STAFF REPORT

FROM: Sonya Allen, Associate Planner
208-884-5533

SUBJECT: H-2020-0047
Prescott Ridge – AZ, PP, PS, ~~ALT~~

LOCATION: South of W. Chinden Blvd. and east of N. McDermott Rd., in the North ½ of Section 28, Township 4N., Range 1W.
(Parcels: S0428233640, R6991222210, S0428120950, S0428131315, S0428131200, S0428211102)

A. Master Plan Conceptual Rendering & Medical Campus Conceptual Development Plan - REVISED

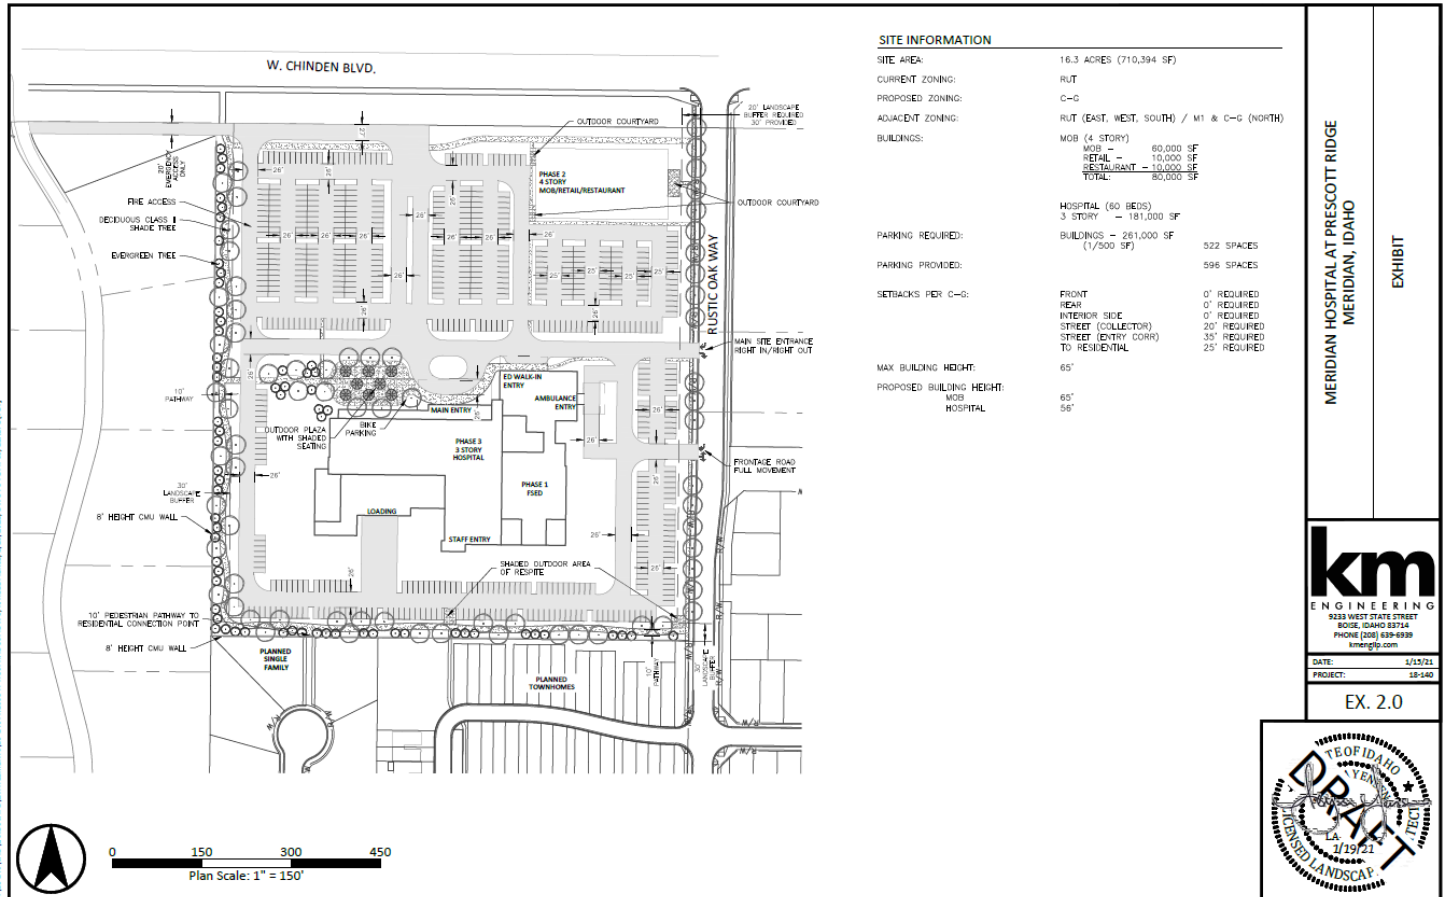
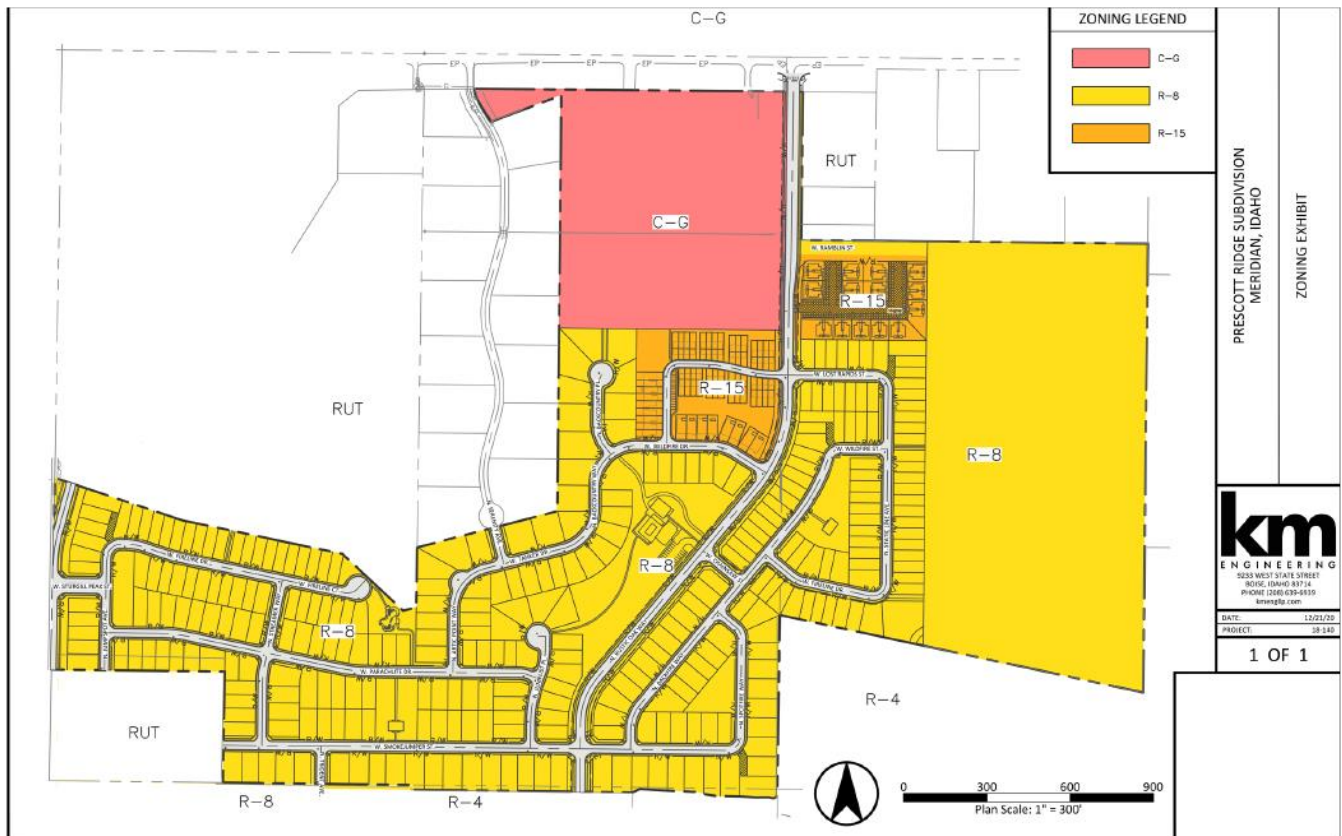
- “In developments where multiple commercial and/or office buildings are proposed, the buildings should be arranged to create some form of common, usable area, such as a plaza or green space.”
The Master Plan depicts ~~an outdoor yard area at the south end of the hospital a shaded sitting area~~ three (3) outdoor courtyard areas in front of around the medical office building, a large outdoor plaza/green space area in front of the hospital with a shaded seating area, and a pedestrian pathway within a 30’ wide landscaped common area along the southern and western boundaries of the commercial portion of the development abutting residential uses with two (2) shaded areas of respite. Staff recommends the concept plan is revised prior to the City Council hearing to reflect common usable area such as a plaza or green space more central to the development with buildings arranged around the common area in accord with this provision.

- “The site plan should depict a transitional use and/or landscaped buffering between commercial and existing low- or medium-density residential development.”
There are existing low density homes on 1-acre lots along the west boundary of this site in Peregrine Heights Subdivision adjacent to the area proposed to be zoned C-G and developed with a medical campus. A 30’ wide densely landscaped buffer is proposed along the west and south boundaries of the C-G zoned property adjacent to existing and proposed abutting residential uses along with an 8’ tall CMU wall as a buffer to future commercial uses. Parking is proposed along these boundaries except for a 4-story medical office building proposed at the southeast corner of the commercial development, which Staff recommends is shifted to the north to front on the main entry drive aisle off W. Rustic Oak Way as a better transition to the residences to the south.

- b. Relocate the parking on the east side of the medical office building to the west side of the building and shift the building further to the east away from the adjacent residential properties (see revised concept plans in Section VIII.A);

Note: Although tree-lined trees are depicted, parkways with detached sidewalks are not proposed except for along the collector streets (i.e. N. Rustic Oak Way & McDermott Rd.) and on common lot end-caps; an east/west-oriented mew with landscaping is depicted within the townhome portion of the development which is also not proposed.

5. A frontage road parallel to W. Chinden Blvd./SH 20-26 shall be constructed as depicted on the conceptual development plan in Section VIII.A in accord with UDC 11-3H-4B.3e.

7. The entire first floor of the medical office building shall consist of retail and restaurant uses as proposed to provide a mix of uses as desired in the Mixed-Use designated area in accord with the Comprehensive Plan.
8. The final design of the site shall be consistent with the general Mixed Use and Mixed Use – Regional guidelines in the Comprehensive Plan (see pgs. 3-13 thru 3-15 and 3-18 thru 3-19).
9. The buffer along the west boundary of the site shall incorporate a 2-foot tall berm with an 8-foot tall wall on top of the berm to assist in blocking the noise from the commercial development if approved by the Peregrine Heights Homeowner's Association (HOA). If not approved by the HOA, the landscaping and wall shall be installed as depicted on the conceptual development plan.

C. Preliminary Plat (date: ~~8/28/2020~~ 10/21/20 ~~11/20/20~~ 12/22/20), Phasing Plan & Lot Layout Exhibit REVISED

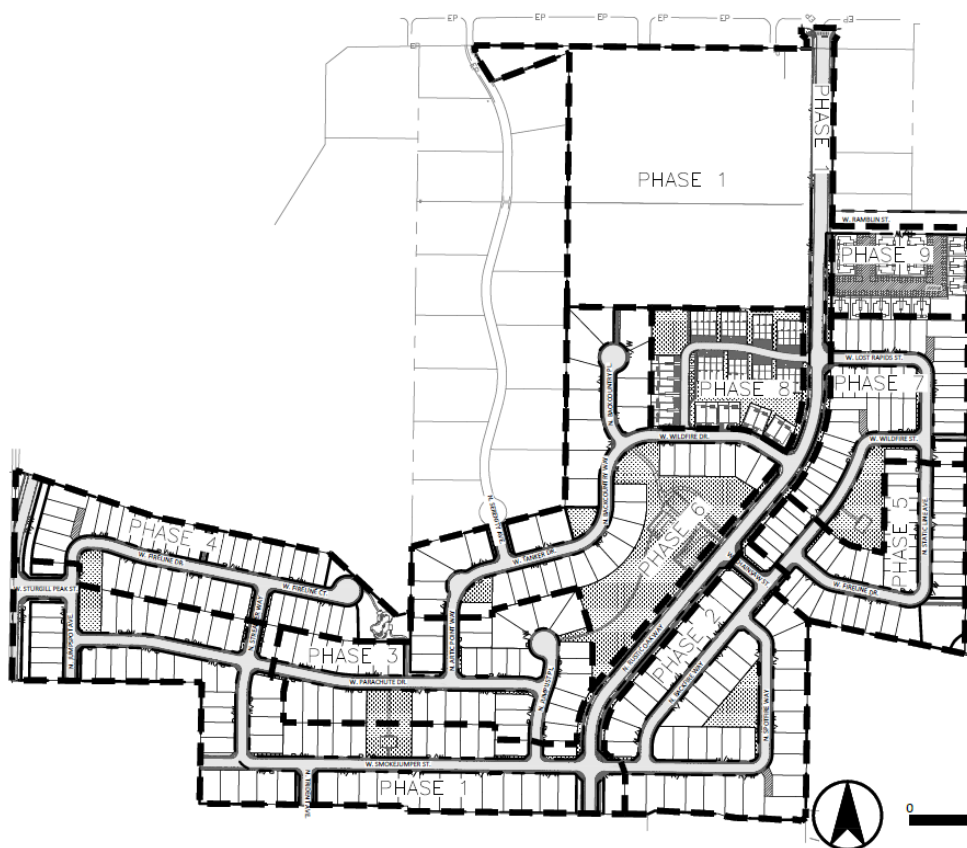
- d. Reduce the number of lots along the southern boundary to provide better transition to the R-4 properties planned to the south in The Oaks subdivision (lots were reduced by 5 along the south and southeast boundaries, see revised plat in Section VIII.C).

- g. Lots 70-83, Block 12 in the multi-family portion of the development shall be revised to depict parking and access driveways on a common lot with an ingress-egress/parking easement for each buildable lot. ~~A revised plat shall be submitted at least 10 days prior to the City Council hearing depicting this change.~~ Done

- h. Extend W. Smokejumper St. as a stub street to the out-parcel (Parcel #S0428233620) at the southwest corner of the site.
3. The landscape plan submitted with the final plat application shall be revised as follows:

D. Landscape Plan (date: ~~8/26/2020~~ 10/9/2020 ~~11/19/20~~ 12/22/20) – REVISED

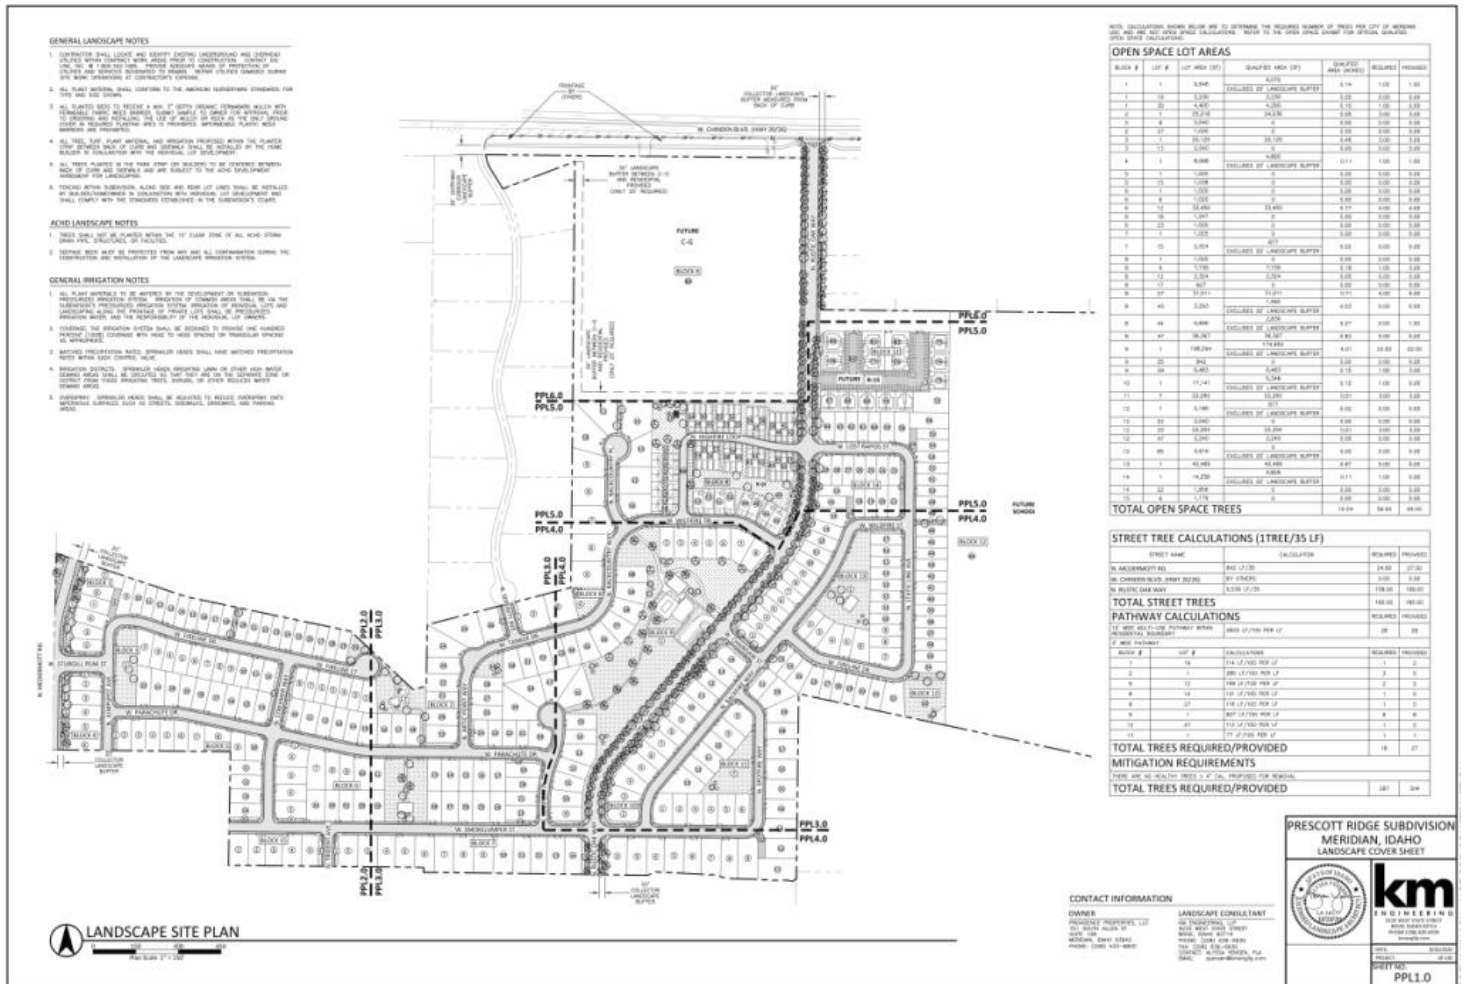
Parkways where provided are required to be landscaped in accord with the standards listed in [UDC 11-3B-7C](#). **The total linear feet of parkways with the required and proposed number of trees should be included in the Landscape Calculations table on the final plat landscape plan to demonstrate compliance with the required standards.**

Landscaping is required along all pathways in accord with the standards listed in [UDC 11-3B-12C](#). **The total lineal feet of pathways with the required and proposed number of trees should be included in the Landscape Calculations table on the final plat landscape plan to demonstrate compliance with UDC standards.**

Common open space is required to be landscaped in accord with the standards listed in [UDC 11-3G-3E](#). **The total square footage of common open space with the required and proposed number of trees should be included in the Landscape Calculations table on the final plat landscape plan to demonstrate compliance with the UDC standards.**

Noise abatement is required to be provided in the form of a berm or a berm and wall combination parallel to W. Chinden Blvd./SH 20-26 constructed in accord with the standards listed in UDC 11-3H-4D. **A detail/cross-section of the proposed noise abatement should be submitted with the final plat application for the commercial portion of the development that demonstrates compliance with the required standards.**

- a. Depict a detail/cross-section of the berm or berm and wall combination required as noise abatement within the street buffer along W. Chinden Blvd./SH 20-26 and N. McDermott Rd.; also address how the wall will be constructed to avoid a monotonous wall, that demonstrates compliance with the standards listed in UDC 11-3H-4D.

- ~~b. Remove Lot 1, Block 15 as it's ACHD right-of-way and cannot be platted as a common lot.~~
 - c. Depict a detached sidewalk/pathway (as applicable) along all collector streets (i.e. N. McDermott Rd., N. Rustic Oak Way and W. Ramblin St.) and W. Chinden Blvd./SH 20-26 in accord with UDC 11-3A-17. *A detached 10-foot wide multi-use pathway is required within the street buffers along N. McDermott Rd., W. Chinden Blvd./SH 20-26, the east side of N. Rustic Oak Way and W. Ramblin St.*

- d. Landscaping shall be depicted on either side of all pathways as set forth in UDC 11-3B-12C.
 - e. If existing trees are proposed to be removed from the site, the Applicant shall coordinate with Matt Perkins, the City Arborist, to determine mitigation requirements per the standards listed in UDC 11-3B-10C.5. Mitigation information shall be included on the plan. If existing trees are proposed to be retained on site, they shall be depicted on the plan.

G. Conceptual Building Elevations/Perspectives - REVISED

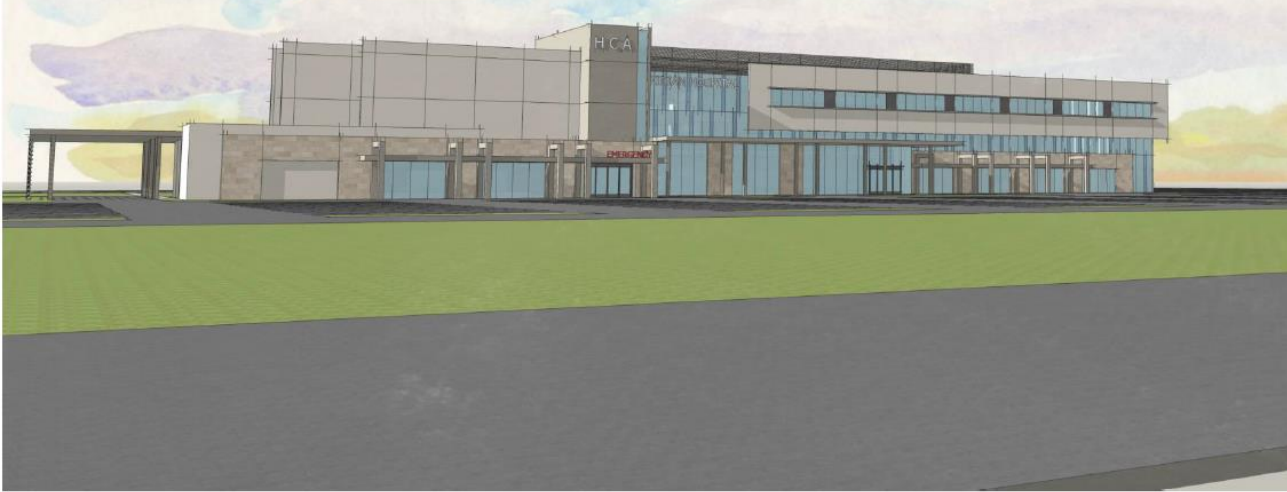
Because the side and/or rear of 2-story homes that face collector streets (i.e. N. McDermott Rd., N. Rustic Oak Way and W. Ramblin St.) will be highly visible, these elevations, should incorporate articulation through changes in two or more of the following: modulation (e.g. projections, recesses, step-backs, pop-outs), bays, banding, porches, balconies, material types, or other integrated architectural elements to break up monotonous wall planes and roof lines that are visible from the subject public street. *Single-story structures are exempt from this requirement.*

Conceptual renderings of the hospital and medical office buildings were submitted as shown in Section VIII.G. The hospital is proposed to be a 3-story building and the medical office building a 4-story building. **The elevations for the medical office building incorrectly depict a 3-story building; these elevations should be revised prior to the City Council hearing to reflect the correct number of stories.**
